RE: Siemens Automotive Corporation
FCC ID: M3N-65981411

The following is in response to the comments made on the above referenced Application.

(Fig. 1)

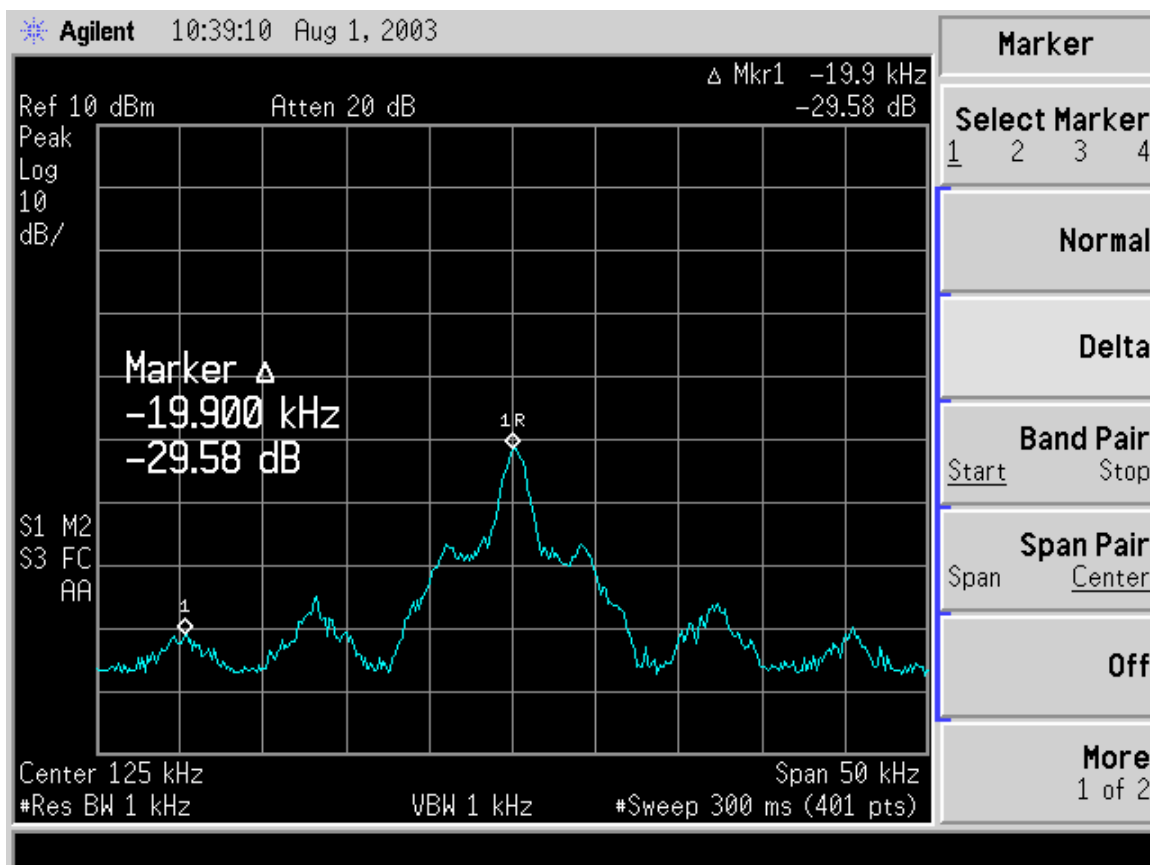
6) According to the bandwidth measured, it appears that part of the bandwidth falls in the 90 – 110 kHz restricted band. Note that the FCC considers all emissions within 26 dB of the fundamental to be modulation products and are therefore part of the fundamental. Therefore all emissions that fall in the restricted band must be < 26 dB below the fundamental, regardless of the power level at the fundamental.

We agree that at 110 kHz the spectrum is down only 18dB (p. 8, Report #415031-167A). Please note that this is the second sidelobe of a $\sin(x)/x$ pattern, and FCC has accepted the argument that the sidelobes can be considered as spurious and not part of the fundamental emission. Siemens has performed an experiment evaluating the operation of the system with reduced bandwidth that demonstrates the sidelobes are not essential for operation of the system. The experiment write-up is attached.

The maximum lower side lobe (105.1kHz) is 29.58dB down from the center frequency power level. The EasyKey system successfully operated with the suppression of this side lobe. Successful operation was monitored using test software to ensure an appropriate transmission to and response from the CID (customer identification device).
